APPLICATION NO.	FILING DATE	FIRST NAMED INVENTOR	ATTORNEY DOCKET NO.	CONFIRMATION NO.
10/580,128	05/19/2006	Michael Holzemer	LYBZ 200104US01 9229	
27885 FAY SHARPE	7590 04/07/201 LLP	EXAMINER		
1228 Euclid Av	enue, 5th Floor	KASTURE, DNYANESH G		
The Halle Build Cleveland, OH		ART UNIT	PAPER NUMBER	
			3746	
			MAIL DATE	DELIVERY MODE
			04/07/2011	PAPER

FINAL REJECTION

This office action is in response to the amendment and remarks filed on 03/21/2011. Claims 1-9, 12-15, 17, 20 and 21 are pending and currently being examined.

Schematic representation of Ando's pumpdown in Column 7, Lines 16-29

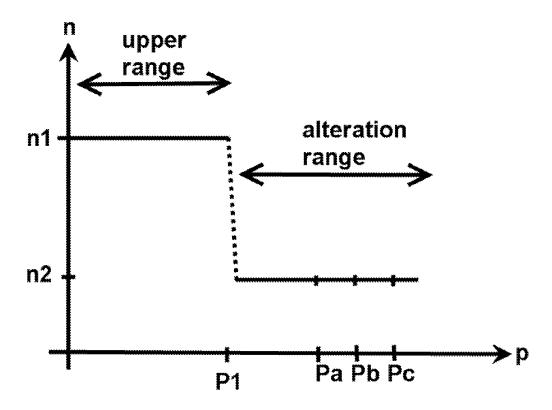
has reached the ultimate pressure or BECOME A RELATIVELY LOW PRESSURE, the rotating speed of the driving motor for the booster screw vacuum pump is REDUCED to the lowest rotating speed to maintain a degree of vacuum required for the evacuated chamber" implies that for ALL values of inlet pressure below P1, the associated corresponding speed value n is "the lowest rotating speed to maintain a degree of vacuum required for the evacuated chamber". Clearly n is less than or equal to n1. The newly added limitation "different" does not overcome this rejection, as discussed below with reference to a schematic that illustrates the pumpdown (evacuation) process of the chamber described in the referenced paragraph:

Each inlet pressure value p (such as "Pa", "Pb", "Pc" annotated above) in the alternation range is associated with a corresponding speed value n2 that is different from speed value n1 corresponding to the upper range

Schematic representation of Ando's pumpdown in Column 7, Lines 16-29

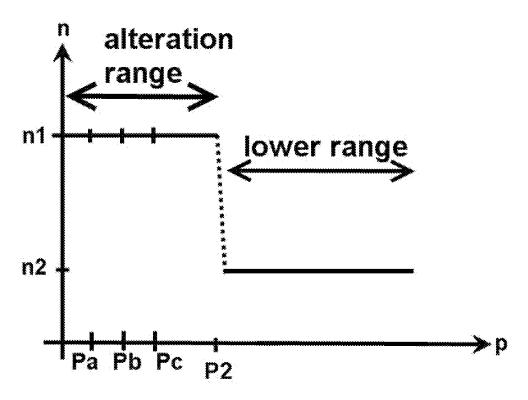
greater than n2. The newly added limitation "different" does not overcome this rejection,

as discussed below with reference to a schematic that illustrates the pumpdown

(evacuation) process of the chamber described in the referenced paragraph:

Each inlet pressure value p (such as "Pa", "Pb", "Pc" annotated above) in the alteration range is associated with a corresponding speed value n1 that is different from speed value n2 corresponding to the lower range.

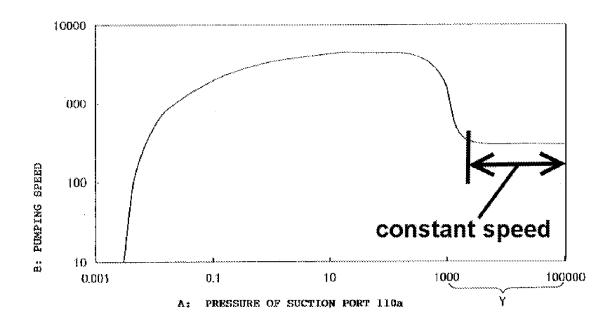
- 32. Applicant has argued on Page 6 of Applicant's Response that the passage of Ando ("as high a rotating speed as possible") referenced by the examiner does not allegedly mean that the speed is constant, and that the quoted passage allegedly only implies that the rotating speed is as high as possible for each pressure value.
- 33. Examiner's Response: The referenced passage does not relate the highest possible speed to PRESSURE as alleged, the passage only refers to the highest possible speed without OVERLOADING the motor. There is no indication in the

referenced passage that the rotating speed is as high as possible for each pressure value. On the contrary there is an indication in Figure 7 that the highest rotating speed possible is constant from about 1000 to 100000 as annotated below:

The annotated range in the figure above refers to pumping speed or flow rate (liters / minute), however, it also implies constant motor speed because in positive displacement pumps, the flow rate is proportional to motor speed. During the initial evacuation (pumpdown), when chamber pressure is relatively high, the pressure head is relatively low and the motor has more than enough power to operate the pump at the maximum speed (highest speed possible without any danger of overloading). Note that even under no-load conditions the motor speed is not unlimited, there should be a
